**METROPOLITAN GOVERNMENT OF NASHVILLE AND DAVIDSON COUNTY**

**STAFF RECOMMENDATION**  
**3707 Richland Avenue**  
**May 16, 2018**

**Application:** Partial demolition; New construction – addition  
**District:** Richland-West End Neighborhood Conservation Zoning Overlay  
**Council District:** 24  
**Map and Parcel Number:** 10405029600  
**Applicant:** Alex Huffstutter  
**Project Lead:** Sean Alexander, sean.alexander@nashvill.gov

**Description of Project:** The applicant is proposing to demolish the original upperstory of an historic one and one-half story house in order to construct a taller upperstory, and to construct a rear addition.

New Renovation

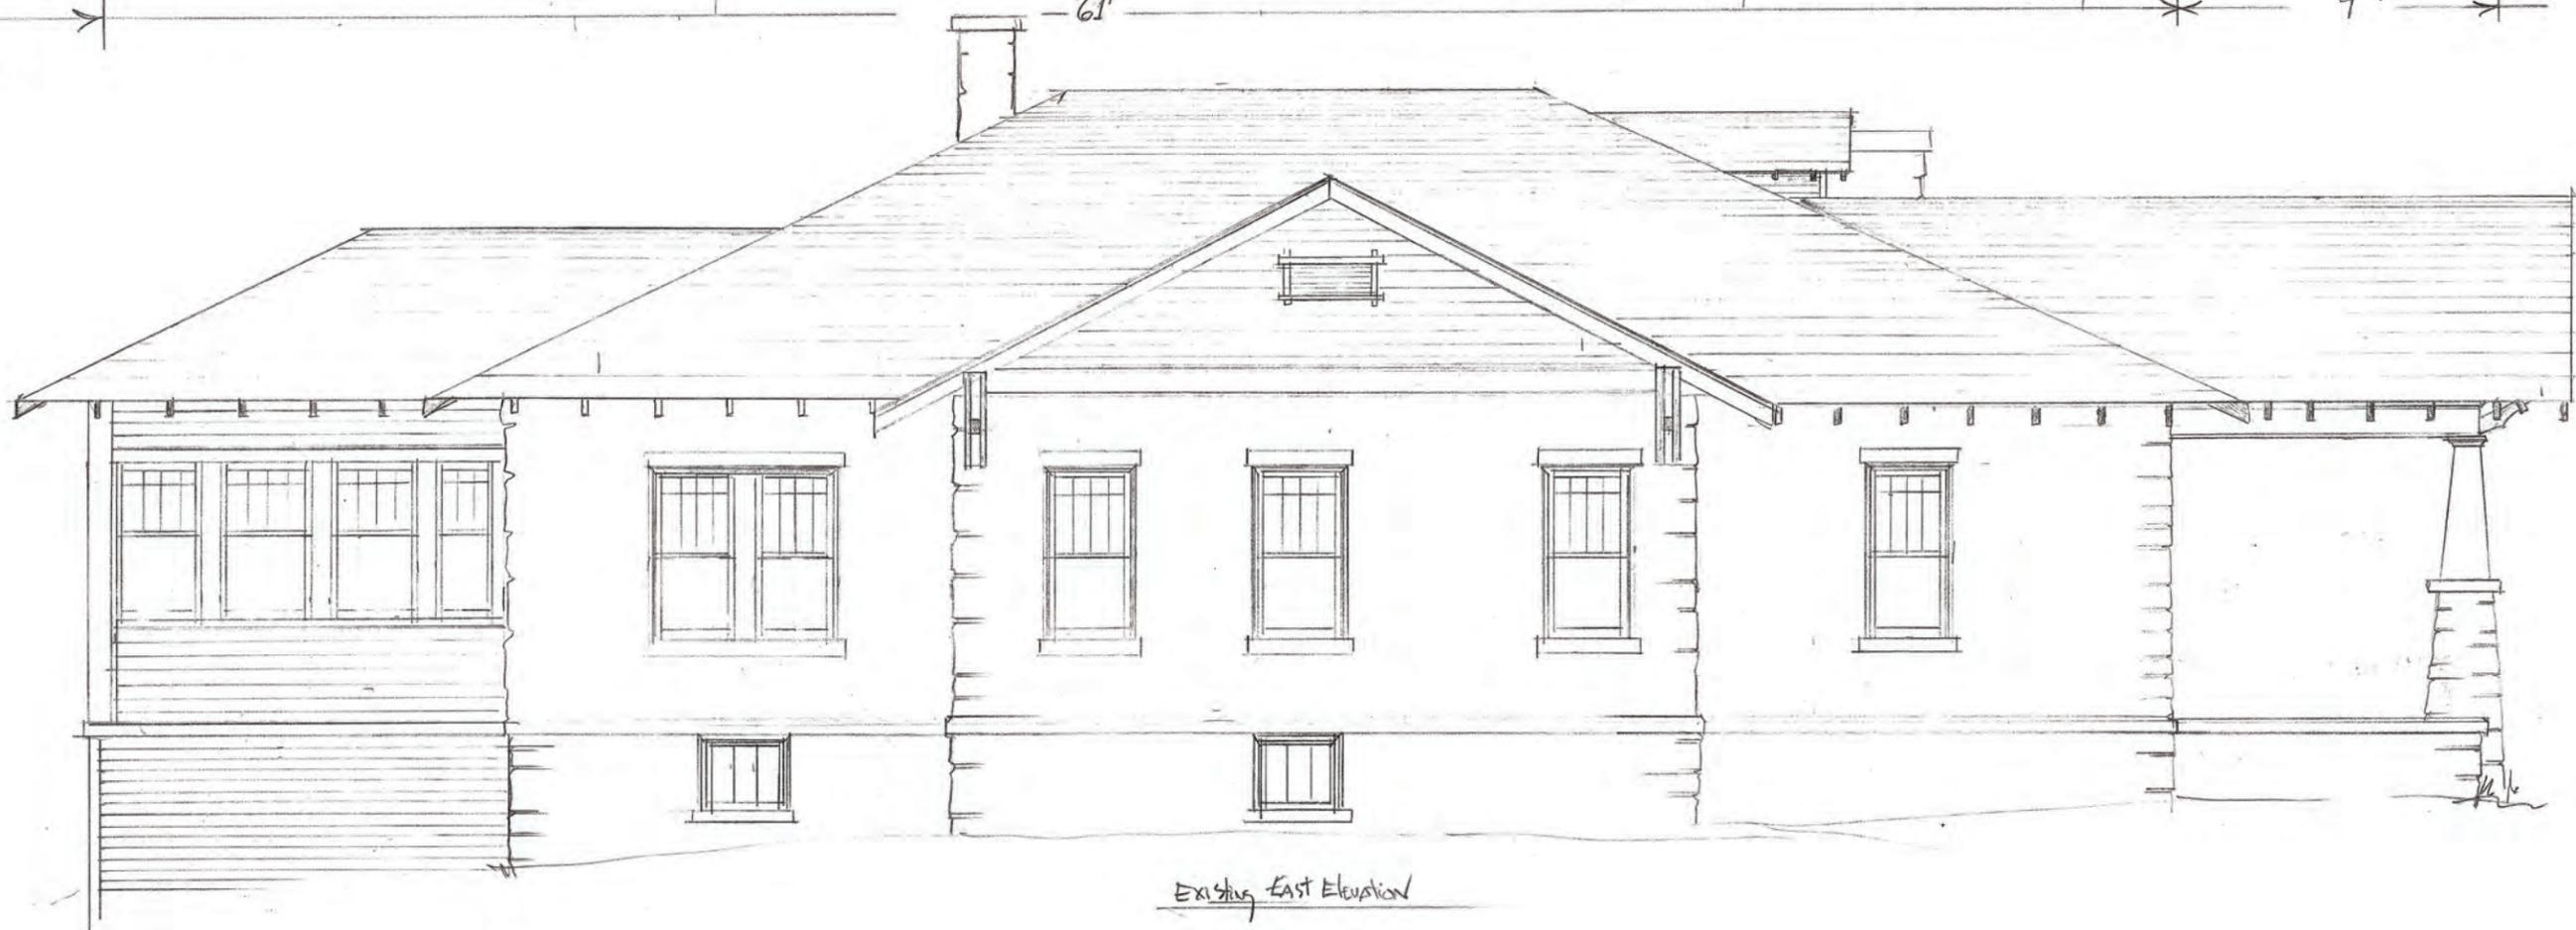
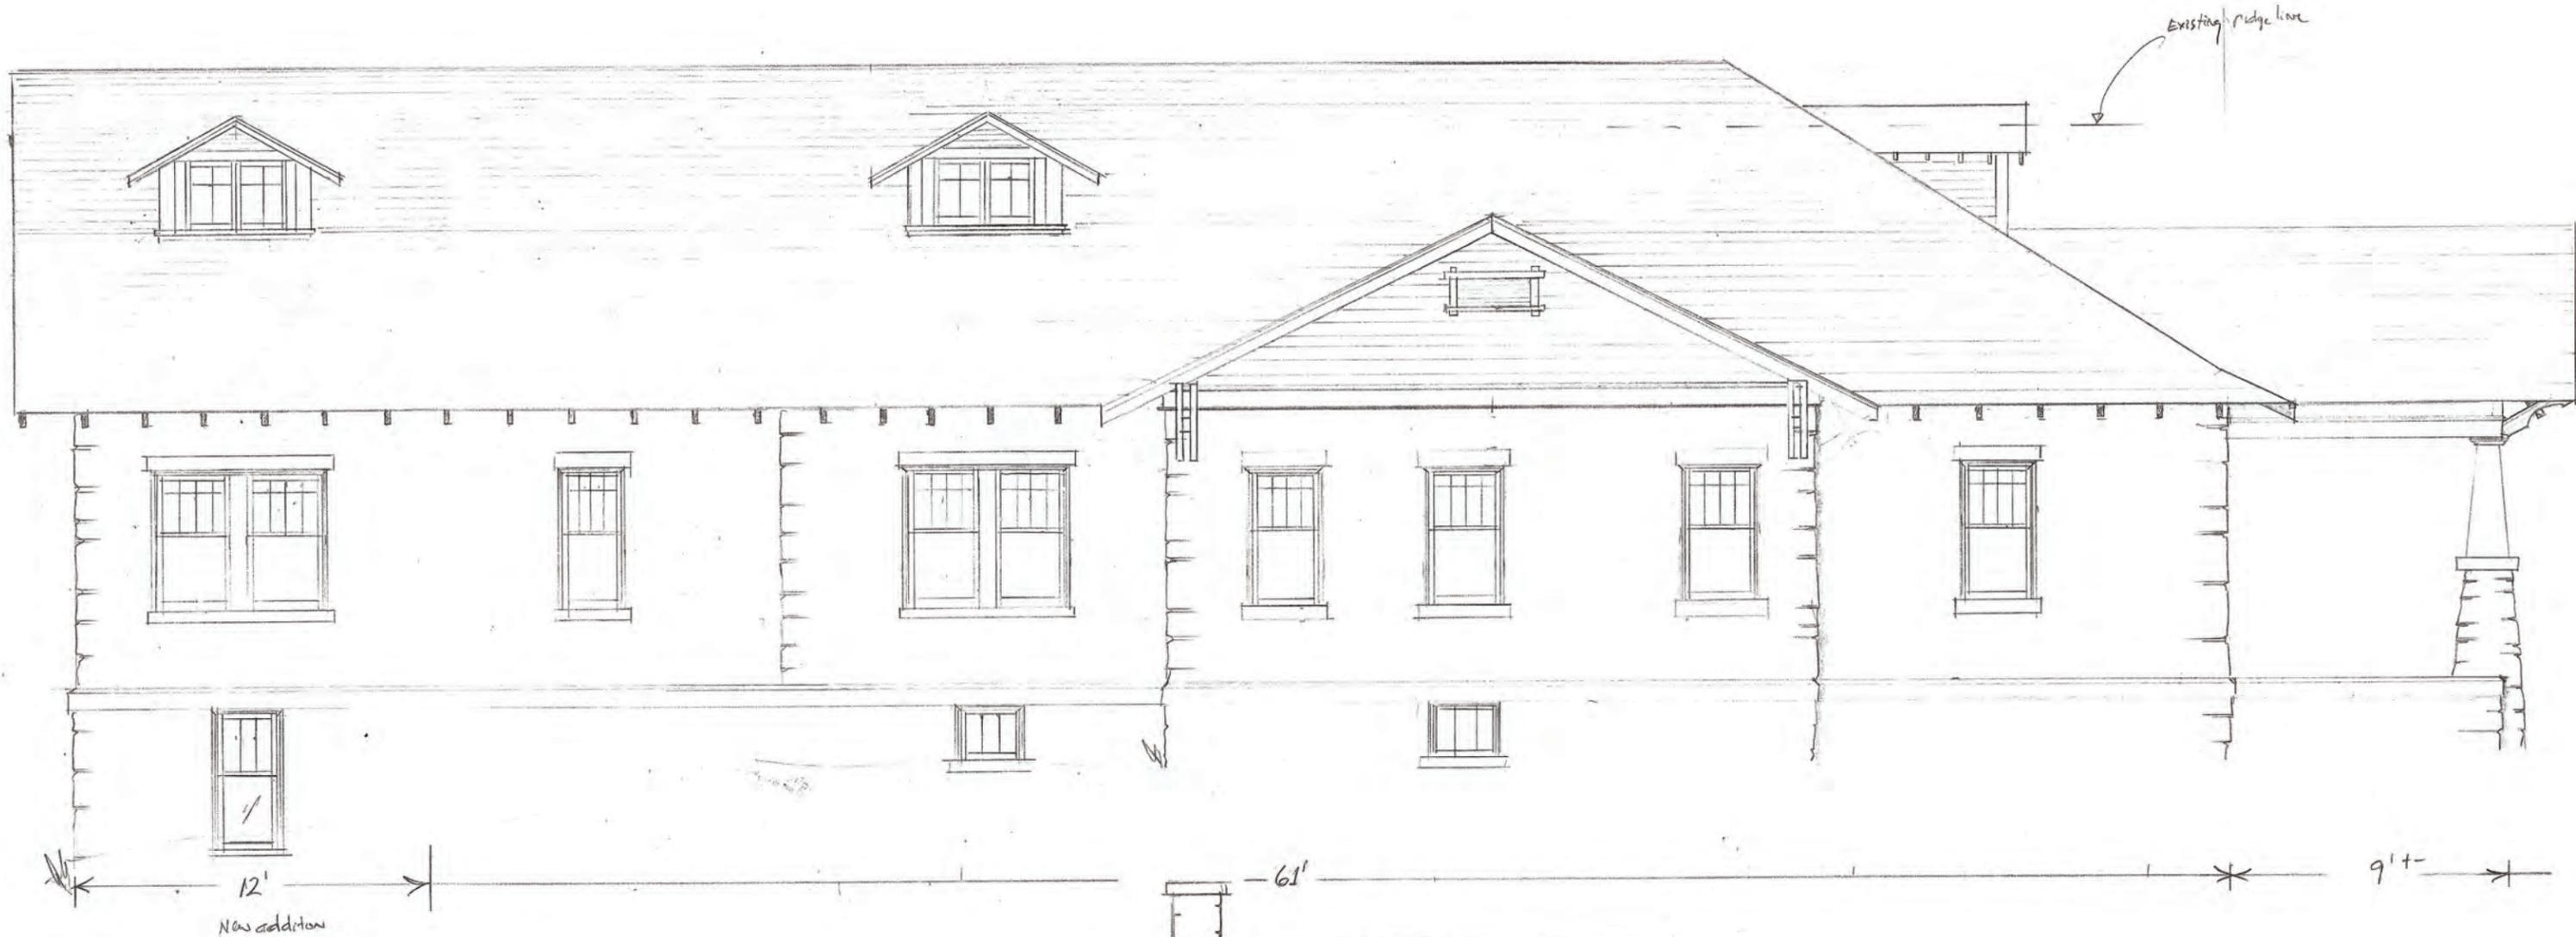
**Demolition:** The roof on the house consists primarily of a hipped form with a front-to-back orientation with a gabled front porch, projecting gabled bays on the left and right side, a projecting hipped rear wing, and hipped dormers on the front and right sides. This complex roof form, with a 5-½:12 pitch on every slope, is original. The applicant proposes to remove the roof entirely and construct a new roof with the same configuration of hips and gables on the front and sides, but with a 7:12 pitch.

**Location & Removability:** In demolishing the upperstory and constructing a new upperstory, the height of the building, from floor level to roof peak, would increase from eighteen feet (18') tall to twenty feet (20') tall. The height of the roof alone, from eave line to roof peak, would increase from eight feet, eight inches (8'-8") to ten feet, eight

inches (10'-8"), an increase of twenty-three percent (23%). This change would be an irreversible alteration of the original massing of the house as viewed from the front and sides. Staff finds that the addition does not meet sections II.B.2.a and II.B.2.d of the design guidelines.

Height & Scale: As described above, the proposal would increase the height of the existing building by two feet (2'). The rear addition would have the same configuration of hips and gables on the front and sides, but in place of the existing rear hip it would extend back with a rear-oriented gable. Because the new roof is dependent on the demolition of the existing upperstory, staff finds that it is not compatible with the historic house and does not meet Sections II.B.1.a and II.B.1.b of the design guidelines.

32'  
New Addition  
South Elevation

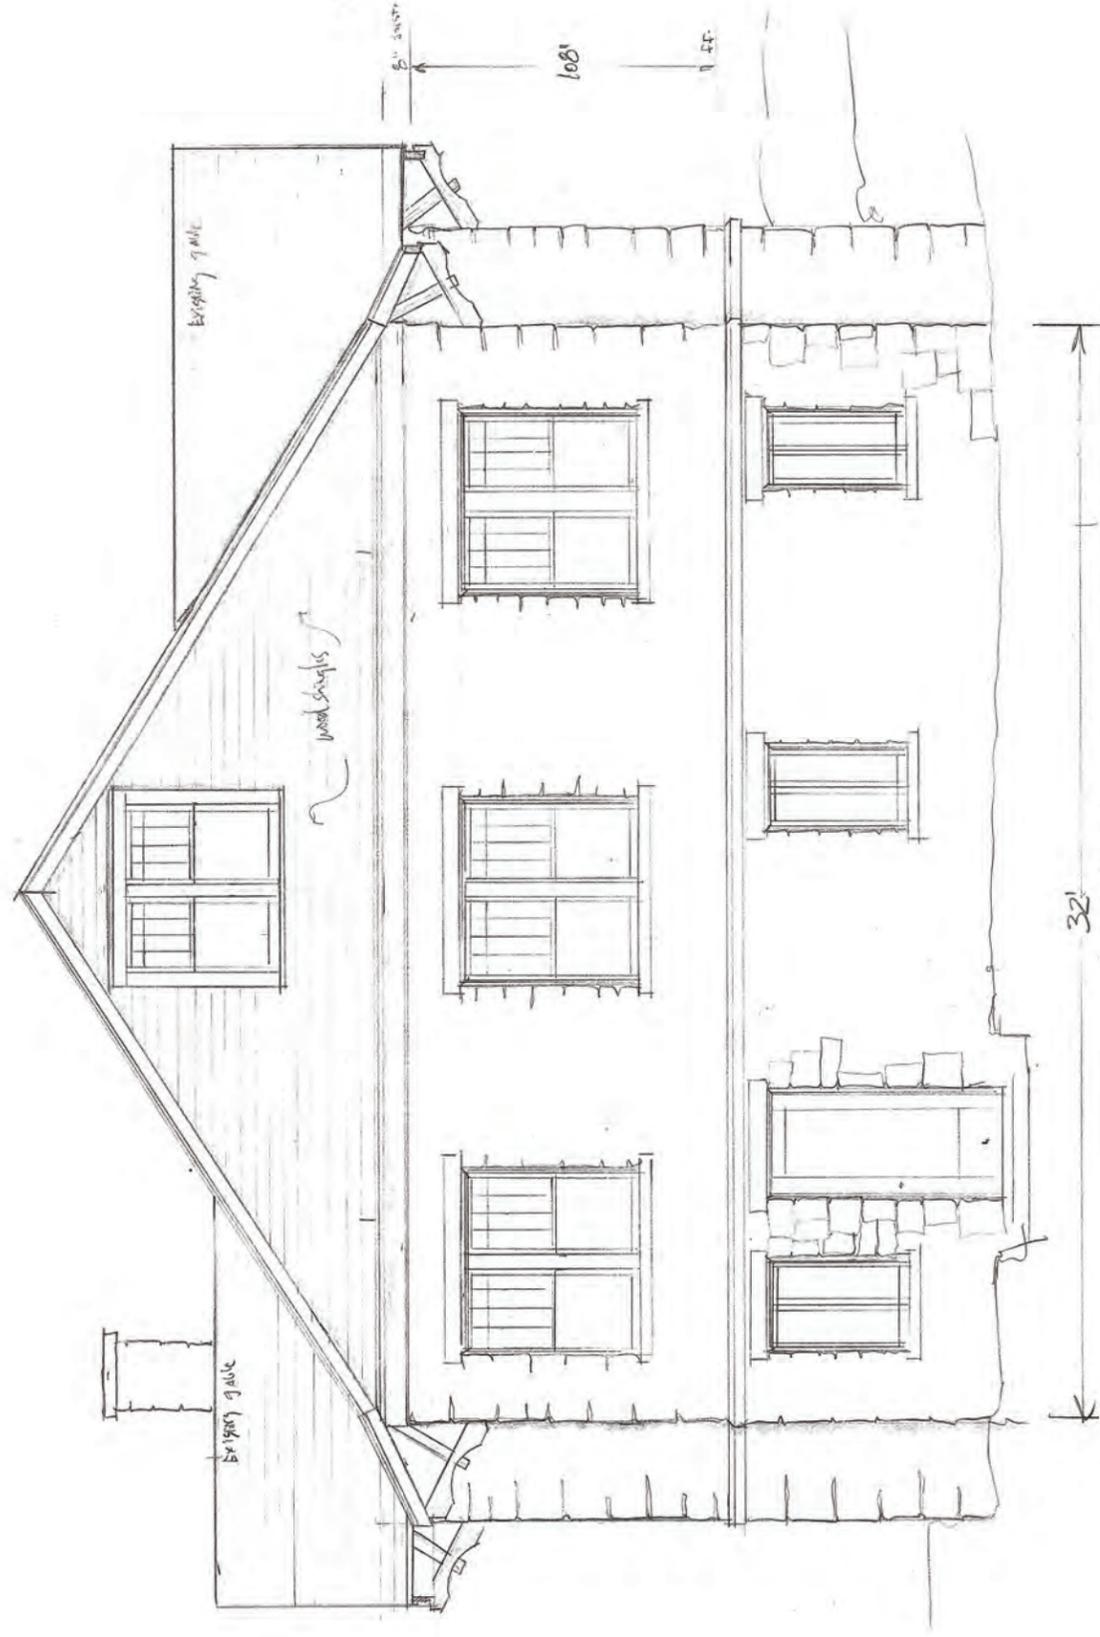
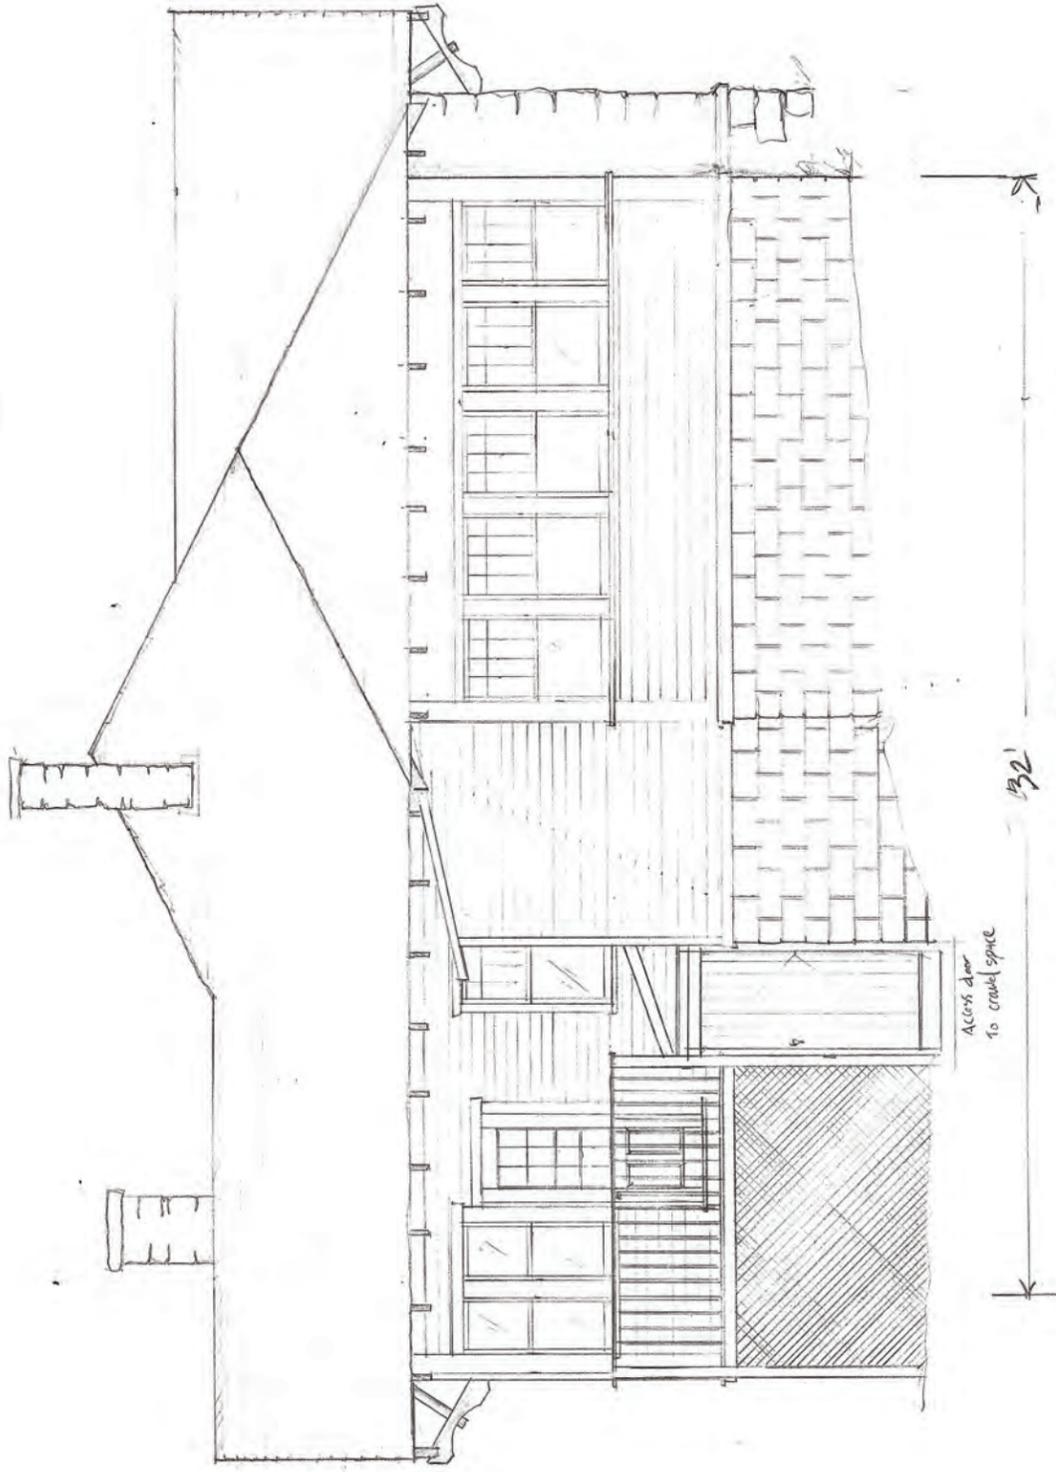
The proposal also includes a one and one-half story rear addition. Although the footprint of the addition is relatively small, the massing of the addition's walls and roofs are inextricably tied to the demolition of the roof and construction of a taller roof.

In order to preserve an historic house's form and differentiate it from new construction, one story additions are typically required to step in one foot (1') from the sides of the existing house where they attach, or to be differentiated by a change in material. The roofs of additions are also typically required to step in from an historic roof to maintain the integrity of the historic form. The proposed addition would align flush with the sides of the existing house where they attach and would match the exterior wall material, and the roof would not be stepped in from the planes of the primary roof.

The footprint of the rear addition would occupy the space where there is currently an enclosed porch and extend twelve feet (12') further to the rear, but it would not be stepped in from the sides or be clad with a different material as is typically required. An addition with a similar footprint may be appropriate if it were sufficiently differentiated from the historic house and did not require the demolition of the upperstory. Such an addition can often be approved administratively.

**Roof form:** In addition to demolishing the upperstory in order to construct a steeper roof, the project includes a rear addition that would not be differentiated from the original roof form, effectively changing the rear from a hip to a gable. The form and pitch of the proposed roofs are not necessarily incompatible with the age and style of the house, but it cannot be considered independent of the inappropriate demolition. Staff therefore finds that the proposal is not compatible with the historic house and that the project does not meet Section II.B.1.e of the design guidelines.
